REMARKS

Claims 1-32 are pending in this application. By this Response, claims 1, 15, 16, 18, 28 and 29 have been amended. Attached hereto is a marked-up version of the changes made to the claims by the current amendment. The attached page is captioned "VERSION WITH MARKINGS TO SHOW CHANGES MADE."

Fig. 3

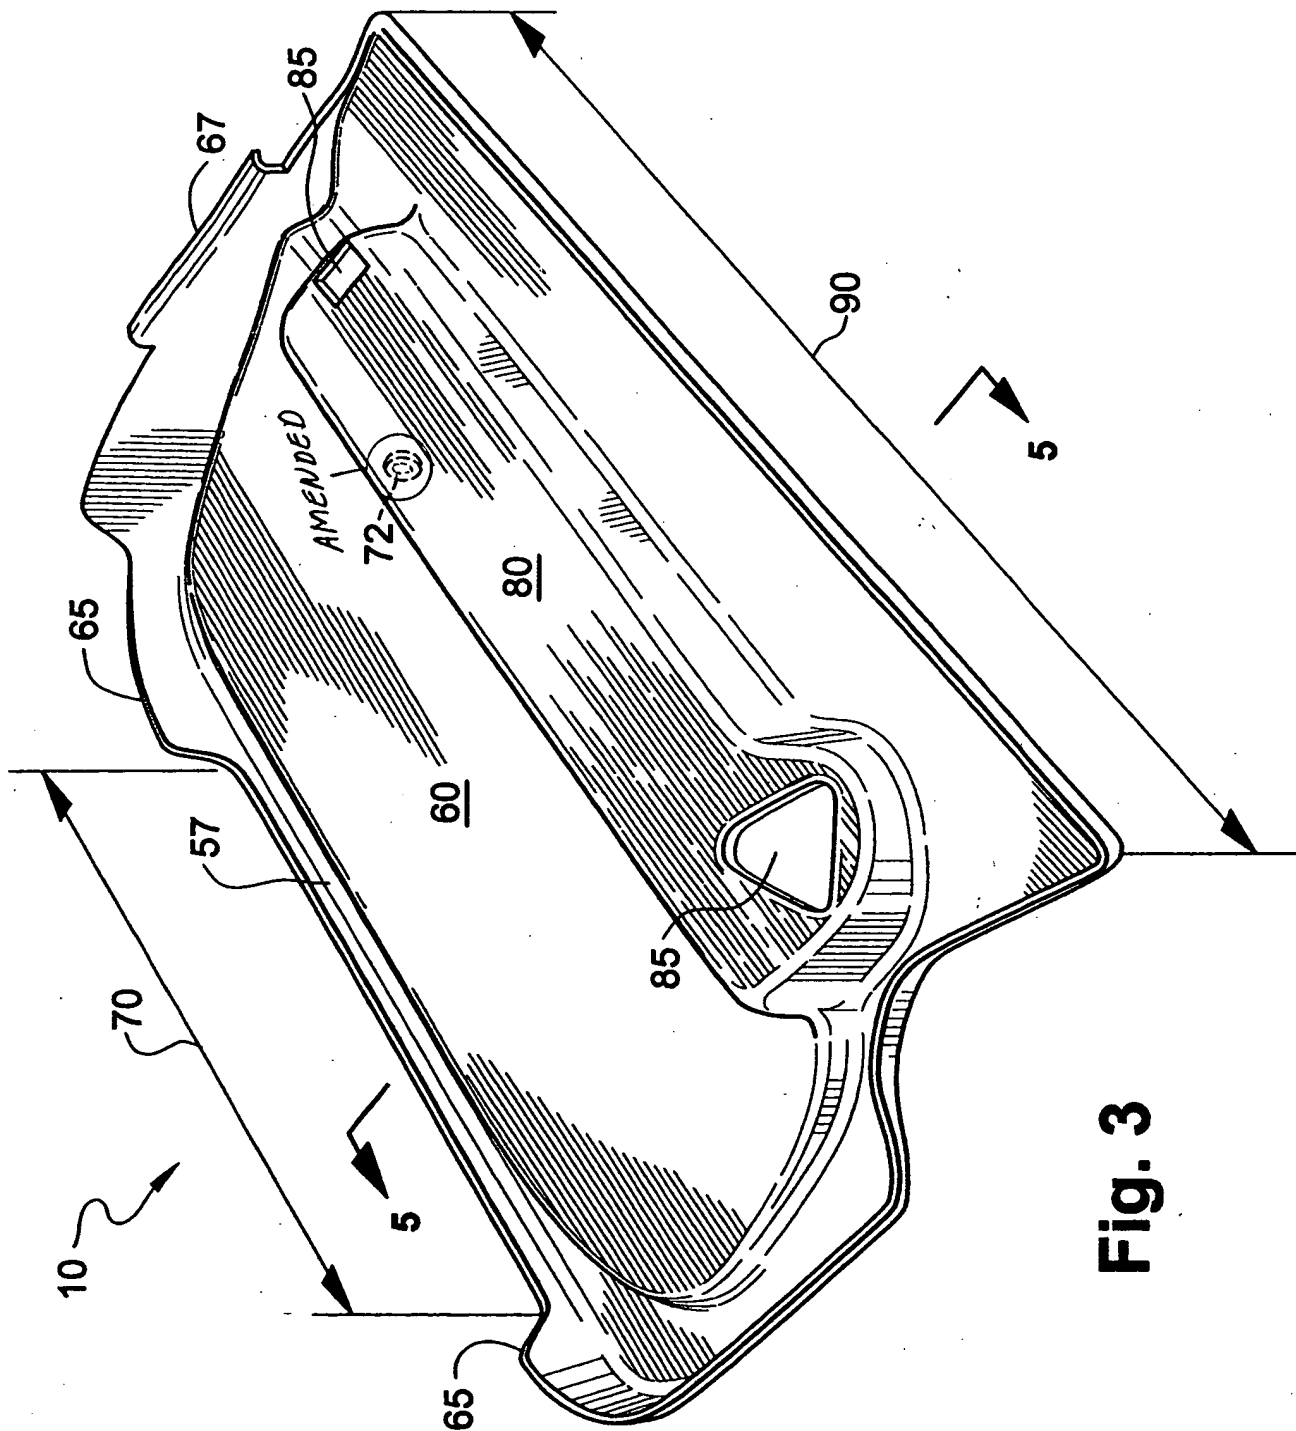
In paragraph 2 of the Office Action, the Examiner objects to the drawings because "the electrical power source coupled to the shelf must be shown." In response, Applicant has amended FIGS. 3 and 4, and submits amended drawing sheets showing the amendment in red ink. It is noted that 37 C.F.R. § 1.83(a) explicitly permits features to be depicted as a rectangular box, so long as the invention can be understood. In this case the "electrical power source coupled to the shelf" encompasses a wide variety of electrical power sources. For understanding claim 14, it is not particularly germane to know the exact details of various embodiments from the vast variety of electrical power sources, which are generically called out in claim 14. Rather, it is important to understand that this hardware can be "coupled to the shelf" as recited in claim 14.

Applicant respectfully requests that the Examiner approve these drawing amendments to facilitate the allowance of this application. Applicant also submits substitute formal drawing sheets for FIGS. 3 and 4.
